# CITY OF ALBUQUERQUE

RE: **Lot 18 Block 5 Volcano Cliffs Unit 18 SAD 228  
6624 Sujeto NW  
Grading and Drainage Plan  
Engineers Stamp Date 4/6/2021 (D10D003K18)  
Pad Certification Date 5/6/2021**

## DRAINAGE AND TRANSPORTATION INFORMATION SHEET (REV 6/2018)

ENGINEER'S SEAL DAVID SOULE P.E. #14522	6624 SUJETO	DRAWN BY WCVJ
	GRADING AND DRAINAGE PLAN	DATE 4-02-21
	 Rio Grande Engineering 1606 CENTRAL AVENUE SE SUITE 201 ALBUQUERQUE, NM 87106 (505) 972-9998	210210039-LAYOUT-4-02-21 SHEET # JOB # 21021039
4/6/21

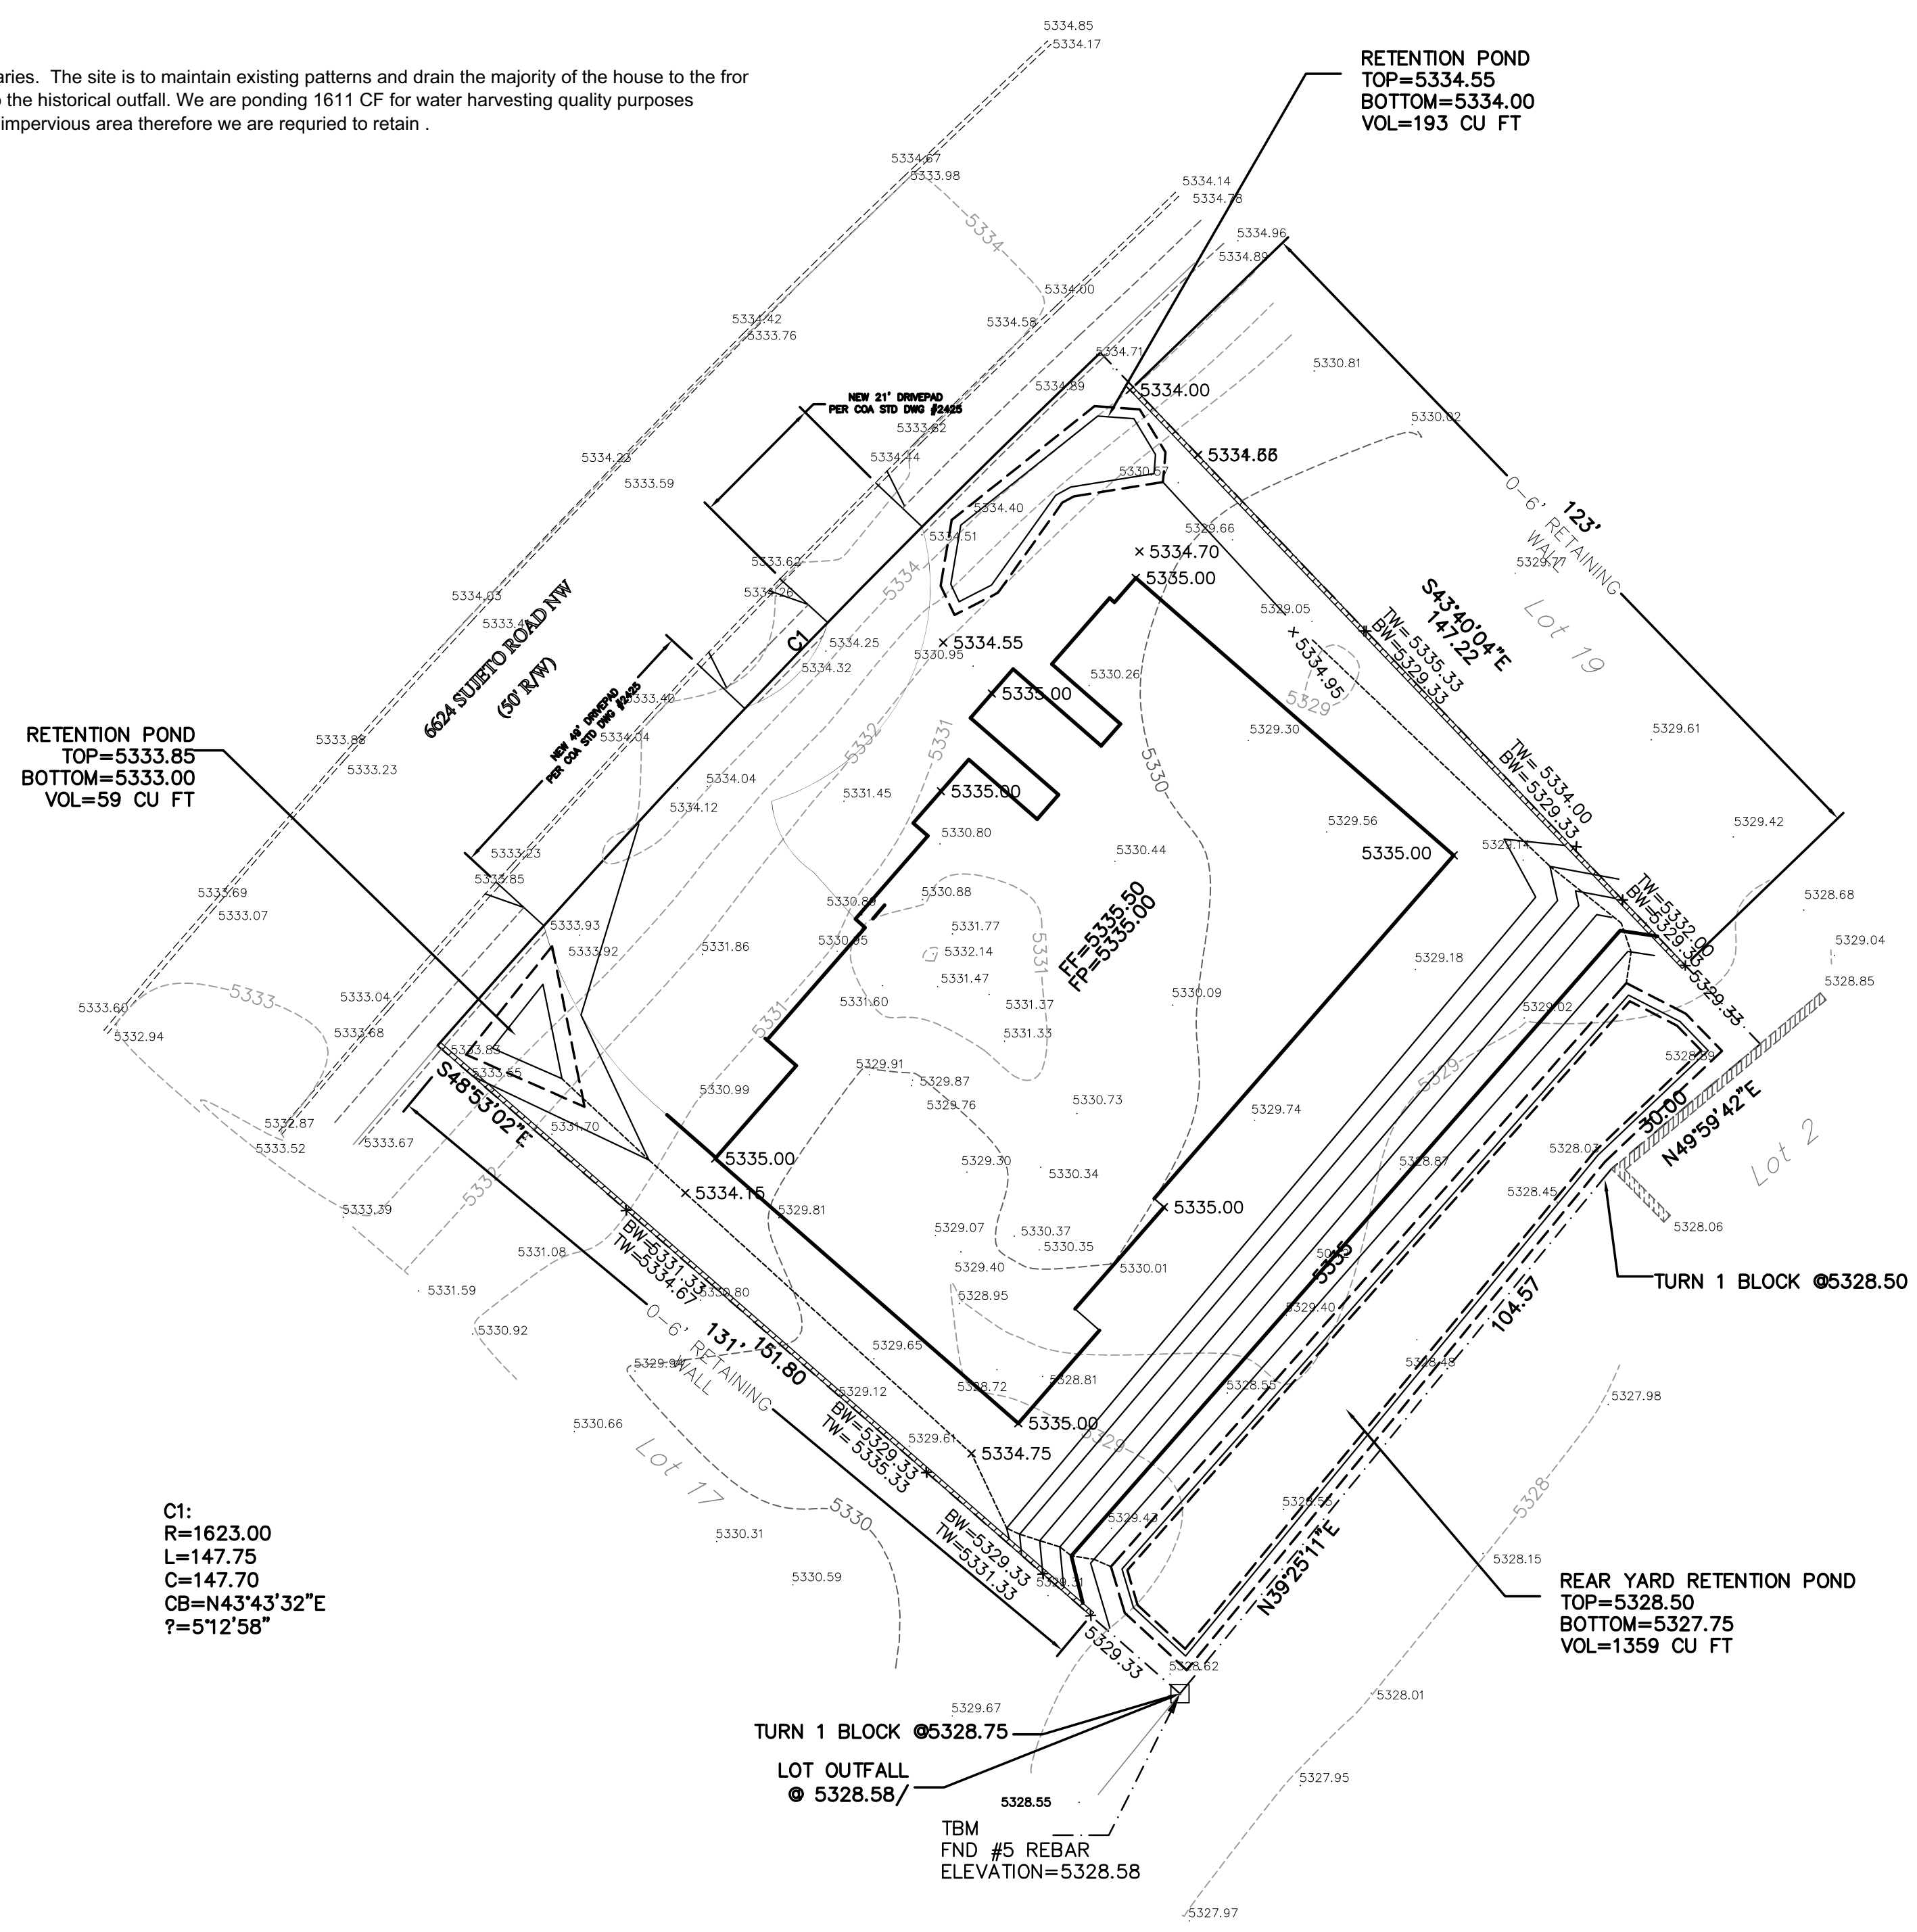
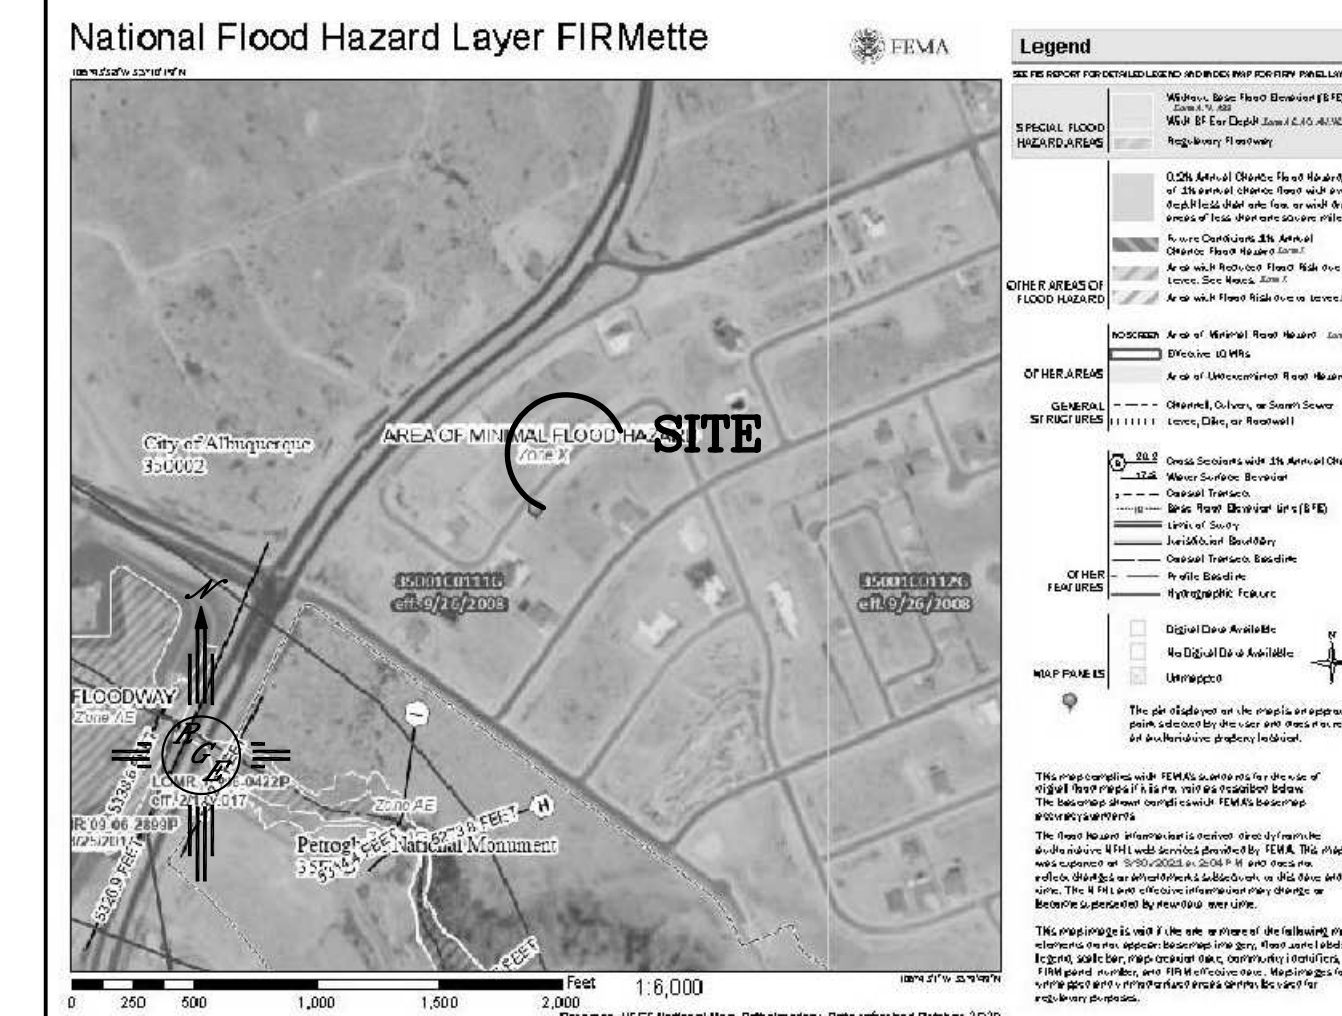
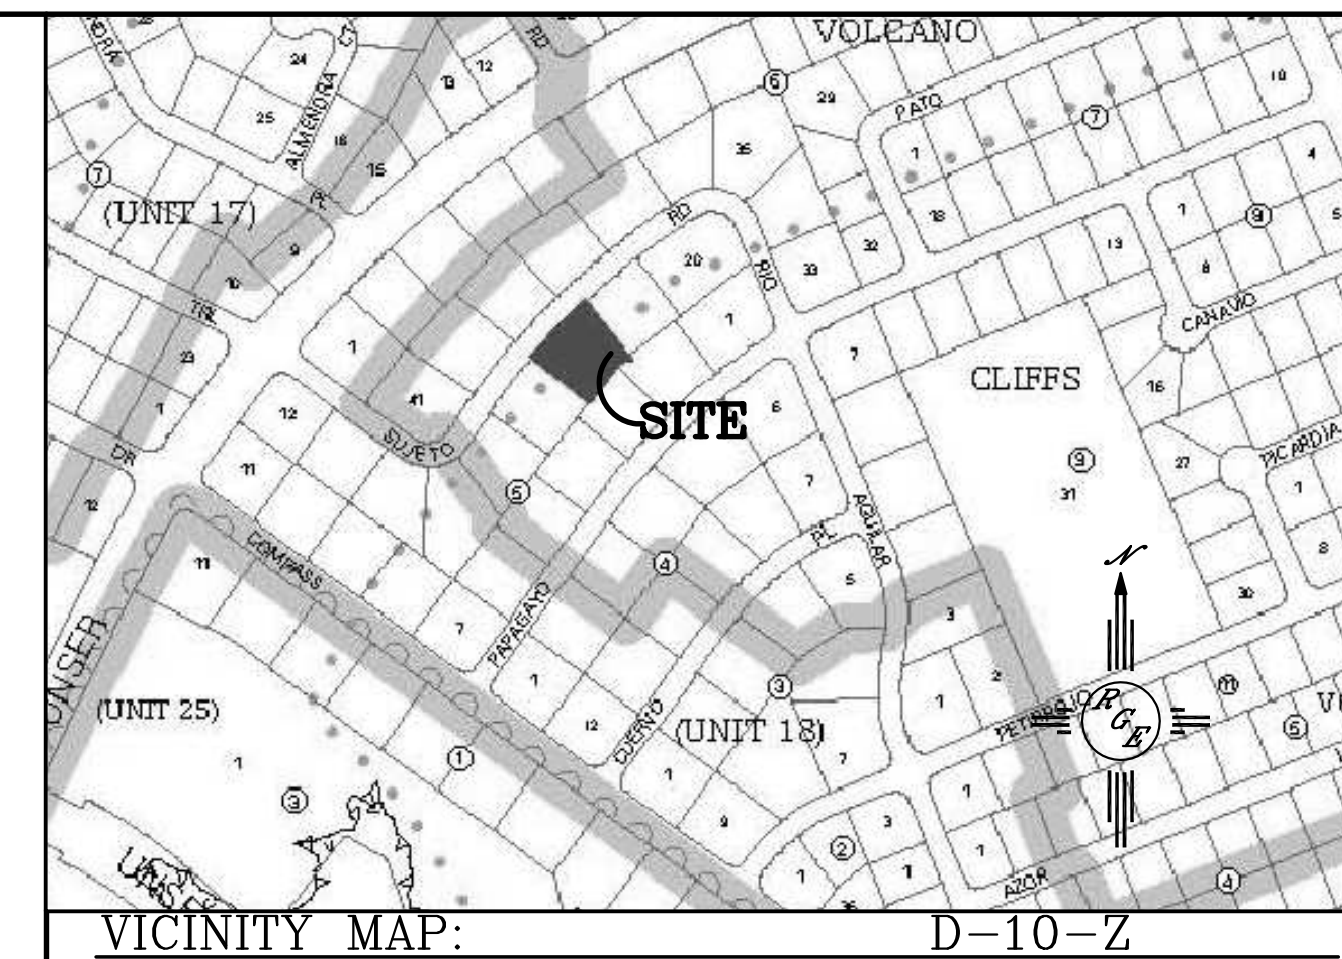
Based upon the information provided in your submittal received 5/6/2021, this plan is approved for Building Permit.

**Reiterate to the Owner/Contractor that a separate permit for a garden/retaining wall must be obtained, with the approved G&D plan and Pad Certification. Also, let the owner/contractor know that if a pool is to be added in the future the G&D plan will need to be modified showing the location of the pool and the land treatment differences.**

Prior to Certificate of Occupancy release, Engineer Certification per the DPM checklist of this plan will be required.
